Technical Service Bulletin

26 Droning, buzzing, or vibration from front of the vehicle

26 19 35 2054935/2 June 13, 2019. Supersedes Technical Service Bulletin Group 26 number 19-34 dated May 6, 2019 for reasons listed below.

Model(s)	Year	VIN Range	Vehicle-Specific Equipment
Q7	2017 - 2018	All	3.0TFSI

Figure 1. Exhaust hanger “A” and decoupling element “B”.

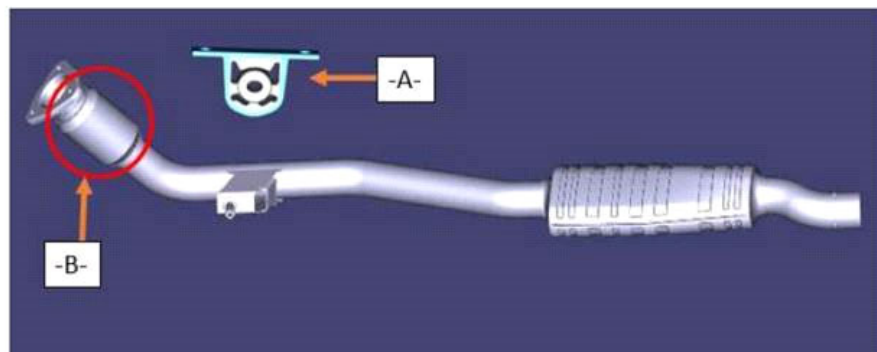
Over time, the exhaust decoupling element may become worn and ineffective.

Vehicles in production receive improved exhaust hangers to reduce NVH. These parts are now available in service.

1. Verify exhaust downpipes as the source of the customer concern.
2. Replace both exhaust downpipes (“exhaust pipe with exhaust muffler, front”) and exhaust hangers (“bracket for exhaust pipe”) with the part numbers outlined below (or any future supersession thereof).
3. Test drive vehicle to verify that the concern is no longer present.
